SERVICE BULLETIN

SB No. 151 Issue No. 1

TITLE INSPECTION OF CANOPY SLIDE LOCK SPRING DIMENSIONS

FIG 1 CANOPY SLIDE LOCK MECHANISM
LOOKING AFT FROM FRAME 6

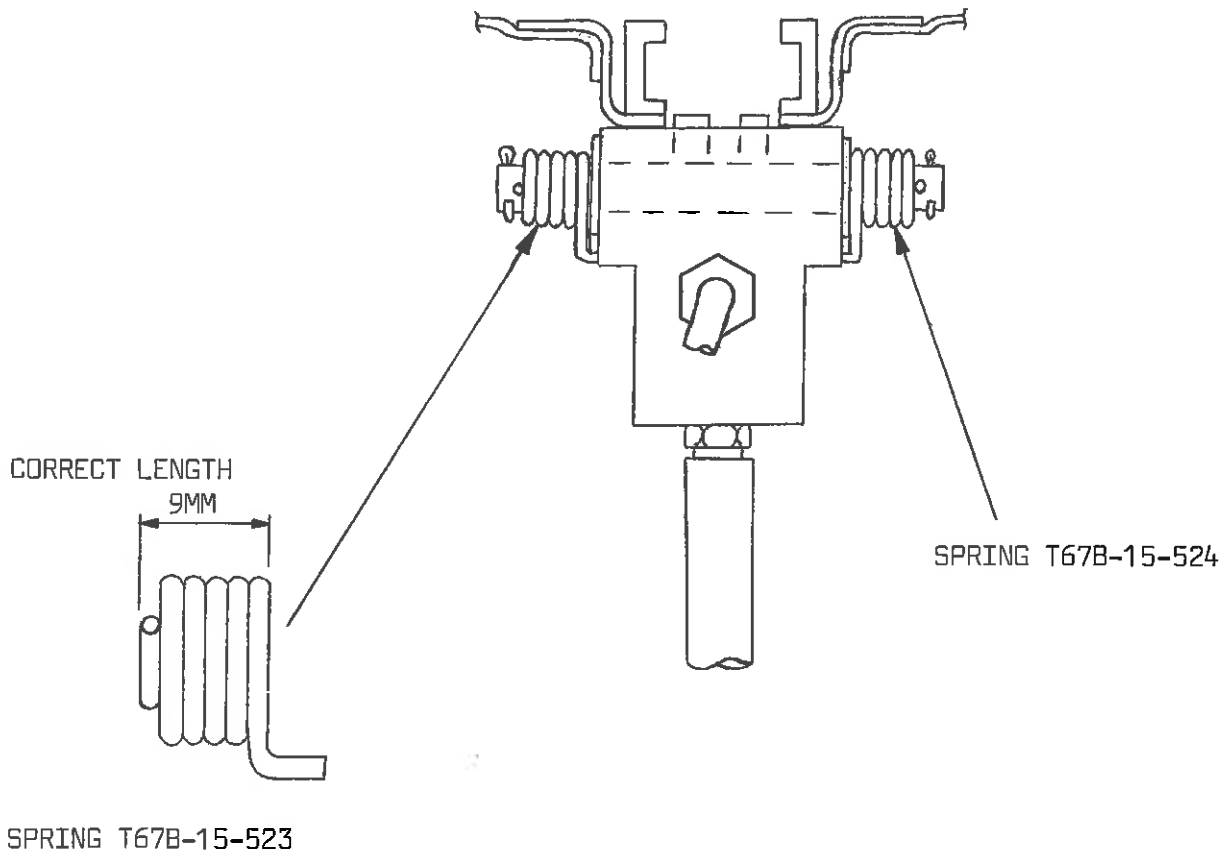
A case (within SAL) has been reported of springs of the incorrect dimensions having been fitted to the canopy slide lock mechanism. This SB requires a one time inspection and rectification.

1. Support and stabilise the tail of the aircraft.
2. Remove rear fuselage access panel located on the front face of frame 5 in the cockpit.
3. Using crawling boards, gain access to the canopy slide lock mechanism located between frames 6 and 7.
4. Measure the dimension shown in Fig. 1 for the two springs.
5. Check any spring held in stock or on catch sub-assemblies T67G-17-801, for the incorrect spring length.
6. If springs are found to be of the correct length (9mm) no further action need be taken. If springs of the incorrect length (7.5mm) are found, they must be replaced with new springs.

Springs Pt Nos T67B-15-523/524 are available from SAL.
7. Re-attach rear fuselage access panel to frame 5.
8. Annotate logbook "SAL SB 151 complied with".
